Conclusion: In view of the defects in the Elemance report, a follow up study should be commissioned to evaluate examples of current state of the art rear impact guards **that have been in service since 2016 and 2017 respectively**. The study should utilize the correct definition of PCI and more accurately assess injury risk.

Figure 1. IIHS Guidelines for rating occupant compartment intrusion ([IIHS, 2024](#))

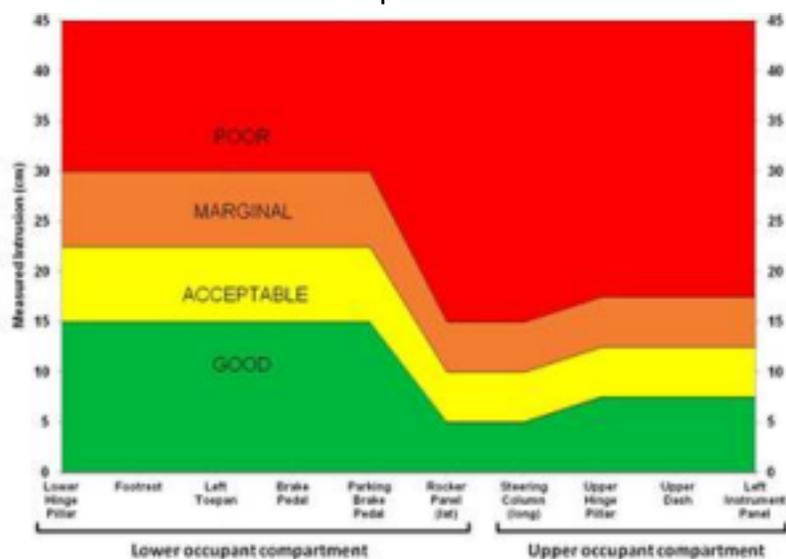
Elemance used an erroneous definition of PCI: Elemance defined passenger compartment intrusion (PCI) incorrectly. In the report, PCI is defined as occurring “when there is trailer **contact** with the windshield, A-pillars, or roof of the striking vehicle” (emphasis added). The authors incorrectly note that this is the same definition used by IIHS in their underride protocol. IIHS does not define PCI in their underride test protocol. The IIHS does, however, define what they consider to be “a successful test (i.e., no underride)” as one in which there is no contact. The IIHS's definition of a successful test does not evaluate injury risk. The Elemance authors have conflated the IIHS definition of a successful test with PCI. The widely accepted [definition of PCI](#), also referred to as occupant compartment deformation, is “loss of the integrity of the vehicle occupant compartment due to a crash [...] resulting in a violation of the occupant compartment” which can be measured directly as the distance the vehicle structure has intruded into the occupant space.

It is well known that the amount of PCI is directly correlated to the injury severity for that affected occupant. In frontal impact crash tests the IIHS [defines](#) allowable location-dependent passenger compartment intrusion values for each rating (Figure 1). The Manual for Assessing Roadside Hardware (MASH) uses similar intrusion values as

The incorrect definition of PCI in Elemance's report was prejudicial. The incorrect definition of PCI makes it appear that the underride guards performed worse than they actually did. By redefining PCI, the authors are only reporting whether or not there was *contact* between the underride guard/trailer and the striking vehicle and not if there was
